# UNITED STATES PATENT AND TRADEMARK OFFICE

APPLICATION NO.	FILING DATE	FIRST NAMED INVENTOR	ATTORNEY DOCKET NO.	CONFIRMATION NO.
10/592,028	09/07/2006	Jeong-Min Lee	L69.12-0006	9384

<b>Office Action Summary</b>	<b>Application No.</b> 10/592,028	<b>Applicant(s)</b> LEE ET AL.	
	<b>Examiner</b> JEFFREY ALLEN	<b>Art Unit</b> 4137

## **DETAILED ACTION**

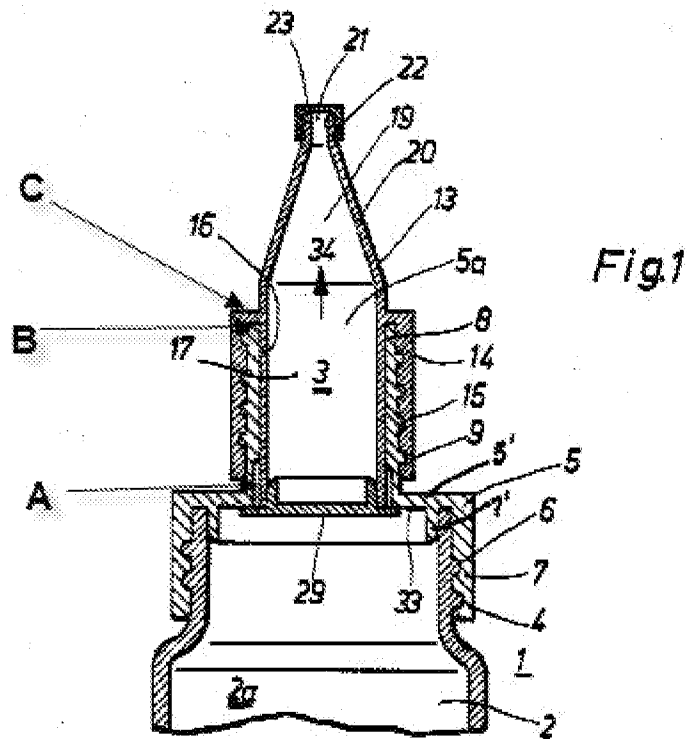
A cap assembly that can be associated with a container storing a primary material (Fig. 1), the cap assembly comprising a lid (5) fixed on a top of the container and having a falling space (A, Fig. 1 below labeled by examiner) and an inner cap body (29) extending from the falling space; and a cap main body (13) detachably coupled to the exhausting portion (8) of the lid and having a storage tube (16) extending downward to define a storage chamber for storing a secondary material, a lower end of the storage chamber being closed by the inner cap body.

A cap assembly that can be associated with a container storing a primary material (Fig. 1), the cap assembly comprising a lid (5) fixed on a top of the container and having a falling space (A) and an inner cap body (29) extending from the falling space; a cap main body (13) detachably coupled to the exhausting portion (8) of the lid and having a storage tube (16) extending downward to define a storage chamber for storing a secondary material, a lower end of the storage chamber being closed by the inner cap body; a cap body

The cap assembly of claim 7 (see rejection of claim 7 above), wherein the cap body is provided at an inner portion with a hooking step (B, Fig. 1 above labeled by examiner) and the storage member is provided with a stopper (C, Fig. 1 above labeled by examiner) that is to be hooked on the hooking step.

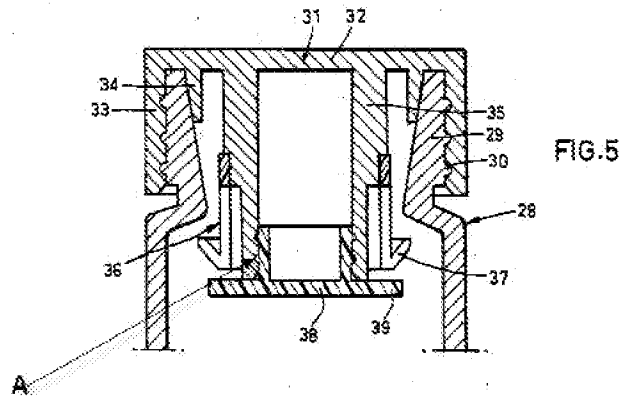
Goncalves teaches that it is known in the art to manufacture a cap with storage space wherein the exhausting portion has a plurality of exhausting pieces (A, Fig. 5 below labeled by examiner) extending from it.

The modified cap of Hildebrandt teaches the cap assembly of claim 15 (see rejection of claim 15 above), wherein the exhausting pieces contact the edge of the inner cap inserted in the lower end of the storage tube (Goncalves, Fig. 5).

The modified cap of Hildebrandt teaches the cap assembly of claim 15 (see rejection of claim 15 above), wherein the exhausting pieces have a bending portion inserted between an upper end of the inner cap body and a lower end of the storage tube (Goncalves, Fig. 5, the exhausting pieces bend inward to form
